## HISTORIC AND DESIGN REVIEW COMMISSION

September 19, 2018

**HDRC CASE NO:** 2018-462  
**ADDRESS:** 201 E HUISACHE AVE  
**LEGAL DESCRIPTION:** NCB 3085 BLK 1 LOT 23  
**ZONING:** MF-33, H  
**CITY COUNCIL DIST.:** 1  
**DISTRICT:** Monte Vista Historic District  
**APPLICANT:** Patrick Christensen  
**OWNER:** SA Huisache Investors LLC  
**TYPE OF WORK:** Window/door replacement  
**APPLICATION RECEIVED:** August 31, 2018  
**60-DAY REVIEW:** October 30, 2018  
**REQUEST:**

The applicant is requesting a Certificate of Appropriateness for approval to replace wood windows and doors with aluminum windows and doors.

The following photos are existing window conditions:

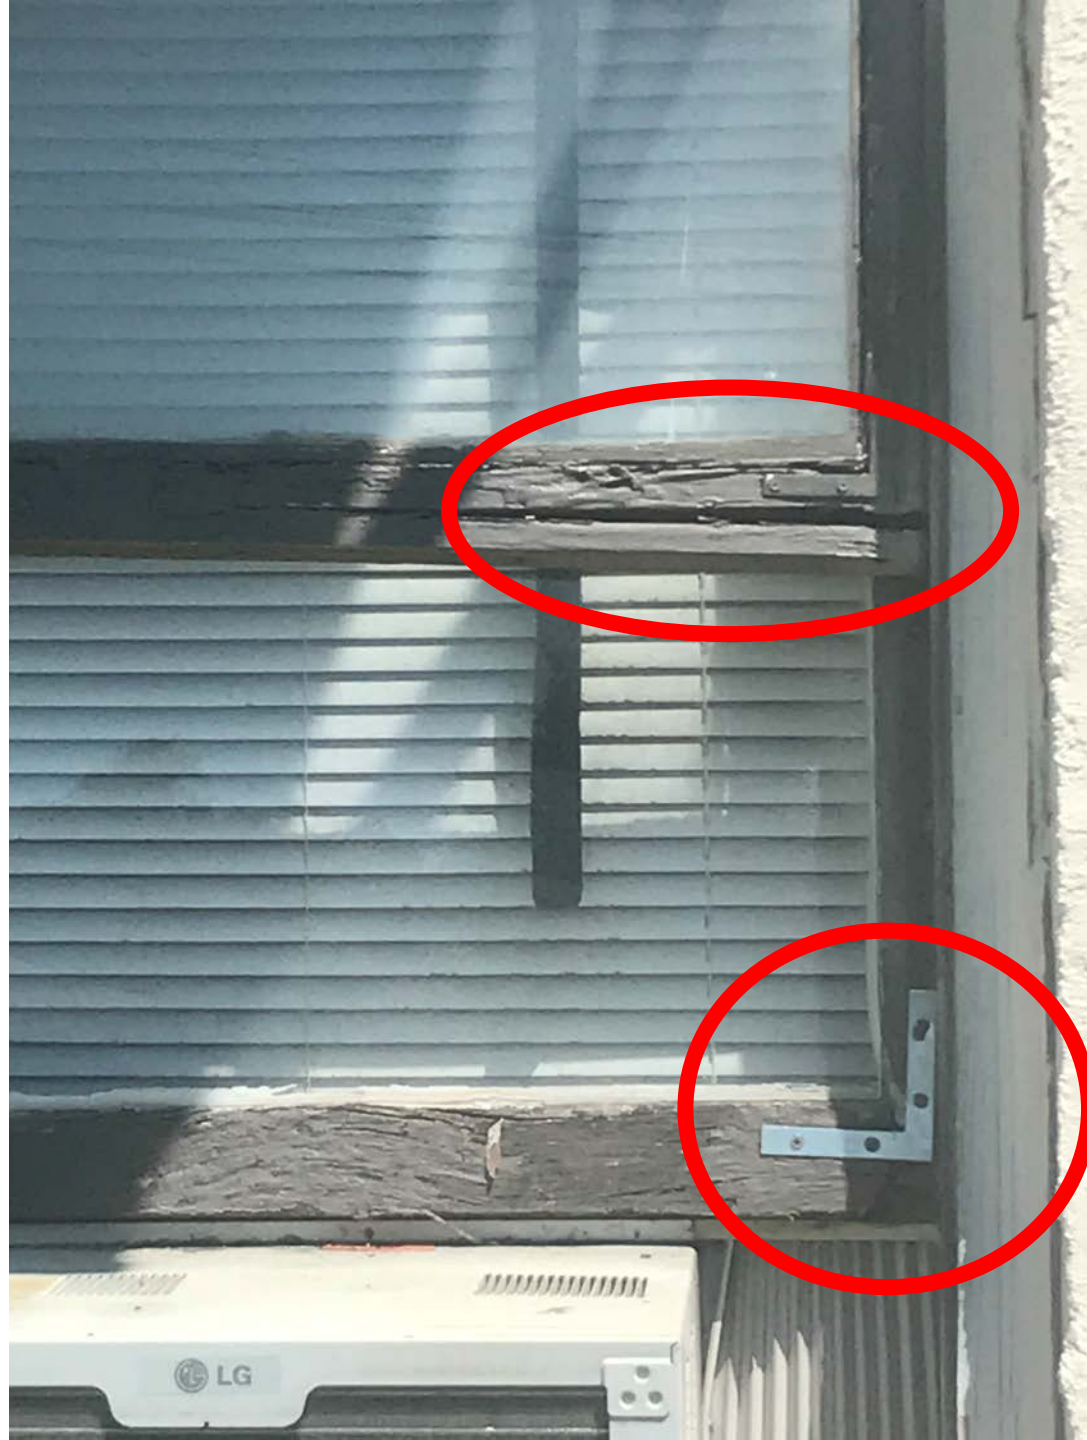
- c. EXISTING WINDOWS – Prior to replacement without approval, the structure featured one-over-one wood windows with a decorative trim as a center piece between each set of windows. Some balconies featured wood doors with 3x5 divided lights.

- d. WINDOW REPLACEMENT – The applicant has proposed to replace a number of wood windows and doors with new aluminum windows and doors. The Guidelines for Architectural Features 6.B.iv. notes that window replacement should only be considered when the original windows are deteriorated beyond repair. While the applicant does provide some supporting evidence regarding wood element failure or broken glazing, staff finds that many of the windows and doors can potentially be repaired. The proposed replacement is not consistent with the Guidelines.

Staff does not recommend approval of window or door replacement based on finding d. Staff recommends repair of any remaining windows and doors.

The following slides are the new windows:

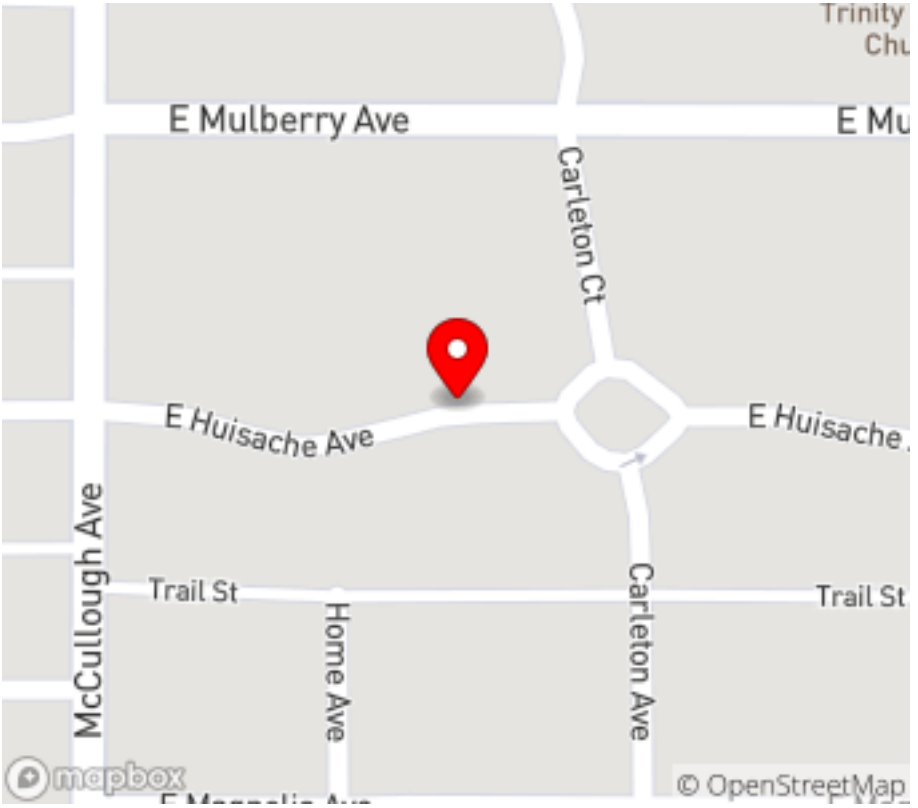
- e. NEW WINDOWS – The applicant has proposed to install black one-over-one aluminum windows. The Guidelines for Architectural Features 6.B.iv. notes that new windows are to match the historic or existing windows in terms of size, type, configuration, material, form, appearance, and details. Staff finds that the proposed windows are not compatible in style or materials with the original windows.

For any window that has been permanently discarded, staff recommends in-kind replacement with the standard stipulations for new windows: *Meeting rails that are no taller than 1.25” and stiles no wider than 2.25”. White manufacturer’s color is not allowed, and color selection must be presented to staff. There should be a minimum of two inches in depth between the front face of the window trim and the front face of the top window sash. This must be accomplished by recessing the window sufficiently within the opening or with the installation of additional window trim to add thickness. Window trim must feature traditional dimensions and an architecturally appropriate sill detail. Window track components must be painted to match the window trim or concealed by a wood window screen set within the opening.*
